**CITY OF MACEDONIA  
BOARD OF ZONING AND BUILDING CODE APPEALS  
MEETING AGENDA  
March 16, 2022**

**To:** Zoning Board of Appeals  
**From:** Chris Hall  
**Subject:** Variance Requests for Don Basch Jewelers, Fairlane Drive  
For Consideration by the Board on April 20, 2022  
**Cc:** Mayor Molnar, Bob Rodic, Rachael Gambatese  
**Date:** February 18, 2022

**DON BASCH JEWELERS  
FAIRLANE DRIVE  
MACEDONIA, OHIO**

**SUBJECT:** Don Basch Jewelry (new building) – Site Plan Review

**A-100**

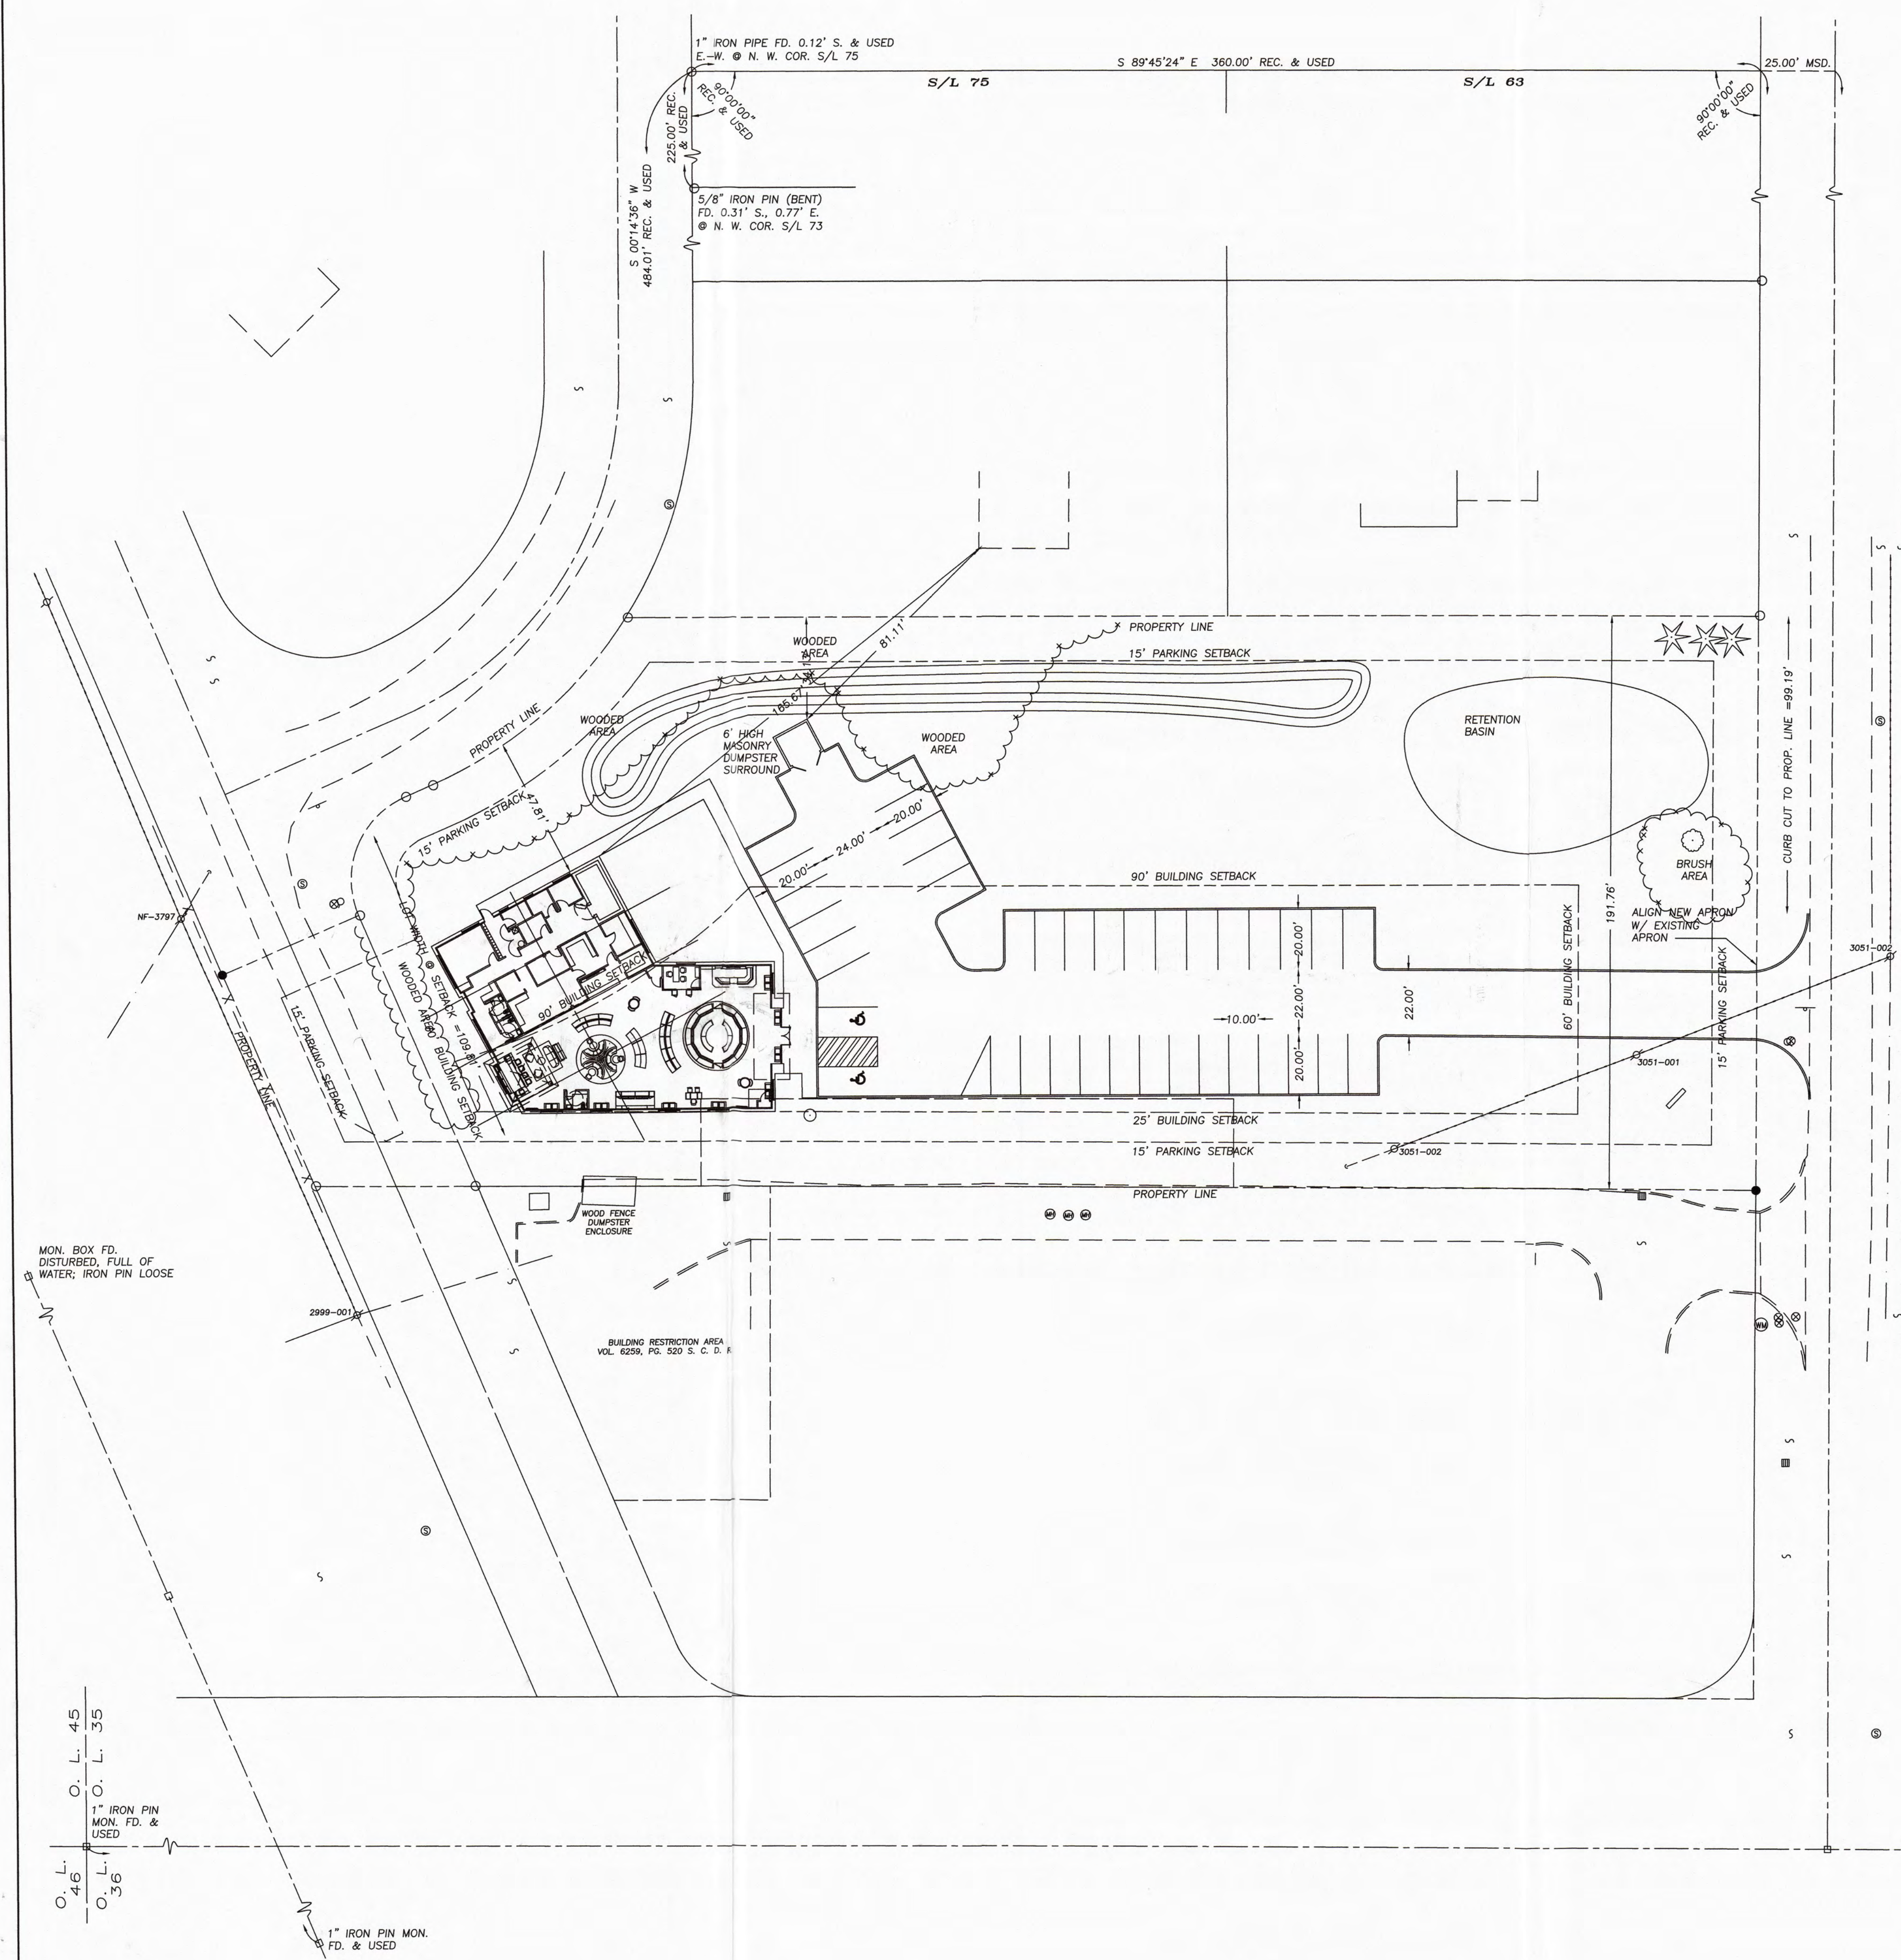
**Findings:** Dumpster relocated from south side of parking lot to north side of parking lot. Reference revised blueprints dated 2/16/22. This variance request was not included in the first submission to the BZA.

**Findings:** Building setback from the public right-of-way as it fronts Route 8 was addressed in Planning Commission. Building setback from the Harmon Road public right-of-way was not addressed.

- Setback (dimensional) – “Mr. Pilato moved to accept the re-proposed Case 628 for a 40-foot set back instead of 21.5 feet with some landscaping.” **ACTION ITEM: The site plan must be updated to provide the property lines compared to the Zoning District boundary lines to ensure the 40 feet is being met.**

- 1) Section 1167.06 (e) requires a 60-foot setback from the public right-of-way. **ACTION ITEM: The building, as it fronts on Route 8, appears to have been adjusted to meet the 60-foot requirement. This will be confirmed once a plan to scale is submitted.**

- 3) Section 1167.06 (j) requires the lot width to be 150 feet at the setback line. **ACTION ITEM: A variance from the BZA might be required to address the lot width at the setback line fronting Route 8.**

**ACTION ITEM: Based on the revised 6,500 square foot building, the required off-street parking is 26 and 33 spaces are provided. The applicant should eliminate three parking spaces from two key locations. First, the single space at the southeast corner of the northern parking lot should be removed and the land area converted to a tree planter. This will eliminate a blind spot for cars entering and exiting the northern parking lot. Second, the two northern most parking spaces in the northern parking lot should be eliminated to provide more turn-around room for cars backing out and exiting the lot.**

- 5) Section 1171.11 (e) (3) requires drive entrances be 60 feet from residential zoning districts. **ACTION ITEM: Previously the plan proposed a 45-foot separation from the adjoining residential district to the north. It appears this condition hasn't changed. To the east (directly across Fairlane Drive) is another commercial plaza where Don Basch Jewelers is currently located. This plaza has two drive entrances from Fairlane Drive and the northern one lines up with parcel #3303242 in the location of the proposed retention pond. In my opinion, the drive entrance to the new Don Basch site should be relocated south to line up with the existing northern drive entrance across Fairlane Drive. This will eliminate an off-set intersection and provide the required 60 feet of driveway separation to the adjacent residential to the north. If the required 60 feet isn't provided, an additional variance from the BZA is needed.**

- 8) A landscape plan has been provided but does not provide dimensions between materials. Moreover, the BZA required screening is set on a mound that can't be dimensioned to

determine proposed separation. **ACTION ITEM: The landscape plan must be revised to include a separate detail for the mound and associated landscape materials to ensure proper separation. To fulfill the BZA requirement, the Commission will need to ensure the landscaping is sufficient to screen the adjoining residential homes.**
